8. Well Name and No.  
MAYER FED 19. API Well No.  
30-015-24041-00-81 **S2**10. Field and Pool or Exploratory Area  
OWEN MESA11. County or Parish, State  
EDDY COUNTY, NM**SUBMIT IN TRIPLICATE - Other instructions on page 2**

OXY USA WTP LP - Current  
Mayer Federal #1  
API No. 30-015-24041

Permanent Abandonment of Federal Wells  
Conditions of Approval

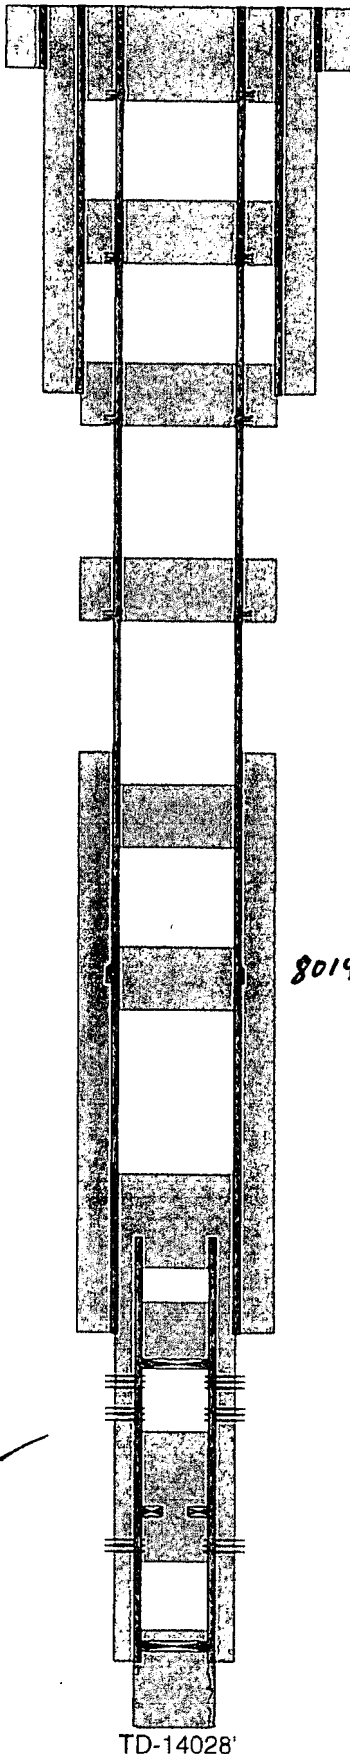
**\*\* BLM REVISED \*\* BLM REVISED \*\* BLM REVISED \*\* BLM REVISED \*\* BLM REVISED \*\***

Add: Perf 970 SQZ cmt 870. WOC Tag.
